# **EXPERT REPORT**

## **EXTENDED INQUIRY (COI 2)**

PROFESSOR DON McQUILLAN

6 December 2019

16. An extract from LCAL’s Drawing No. 1112/B/HHS/ACM/C12/701 Rev C dated 27 May 2016 [DD8/11310] is copied below to show the typical HHS trough wall height, thicknesses and rebar details as intended in the original design.

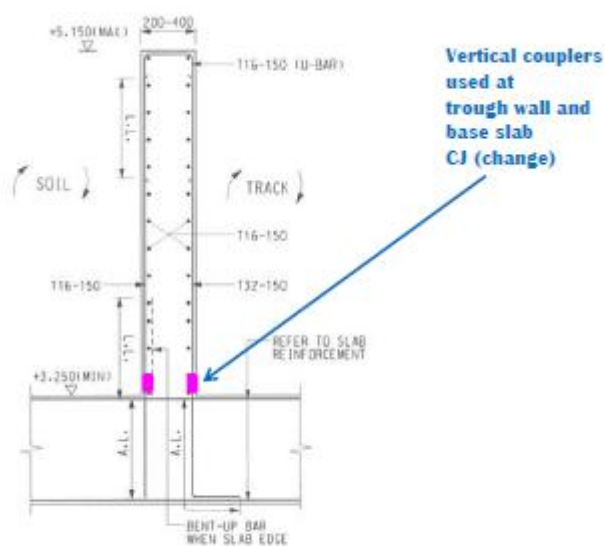
17. Instead of using lapped bars at the kicker, i.e. the wall-top of slab interface, LCAL used mechanical couplers to provide a splice for the vertical rebar on each face of the wall which is acceptable in respect of the HKCOP. This is illustrated in the following diagram courtesy of AECOM [BB17/10151].

20. The decision to impose a strength reduction factor of 35% [BB16/9976/§4.2.6 and §4.5.2] has not been justified because no invasive investigation at all has been

carried out to support the allegation of defective workmanship in the couplers. Instead, the same statistically-based failure rate, premised on partially-engaged coupler assemblies in the rest of the station which are alleged not to contribute structurally, has been applied to a much simpler form of construction. That the trough wall kickers are in any way deficient is therefore pure speculation.

**SAT cross section between EH1 and EH4 with 2,170mm thick base slab**

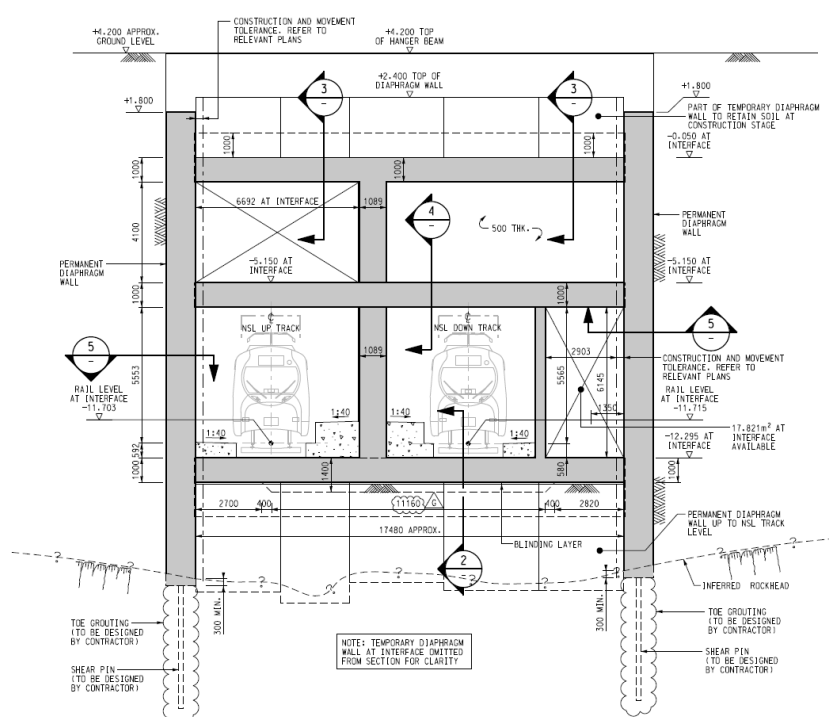
82. By comparison the next typical SAT cross section is copied, courtesy of Atkins, to show the 1m thick base slab which generally exists in that area [AA2/580].

**Photo Records Reference: SAT NSL B38-2**

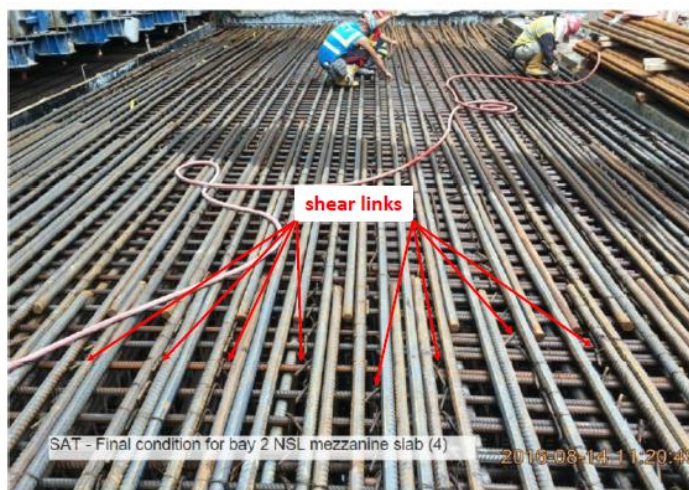
95. In respect of the SAT NSL slabs, Appendix D-2b to the SYW Part 1 Study Report [BB20/12357-12374] contains record photographs taken during construction. I have copied typical photographs below of a) the NSL mezzanine slab rebar [BB20/12369]; and b) the NSL roof slab rebar [BB20/12370]. These clearly show compliant shear links.

**Photo Records Reference: SAT NSL B39-2**

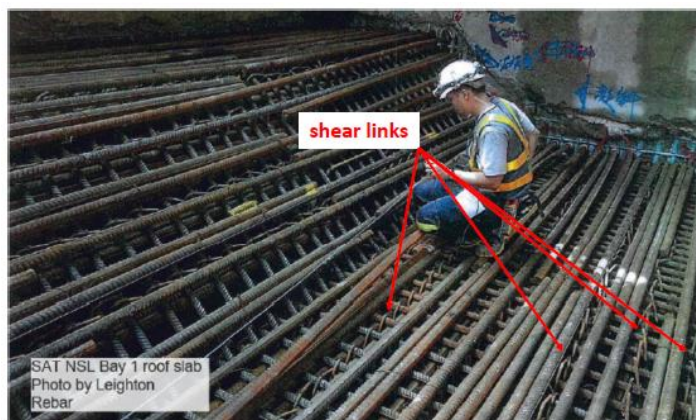
96. Although there are record photographs of the NSL base slab at various stages of rebar assembly, I have not, however, found any showing the completed rebar.
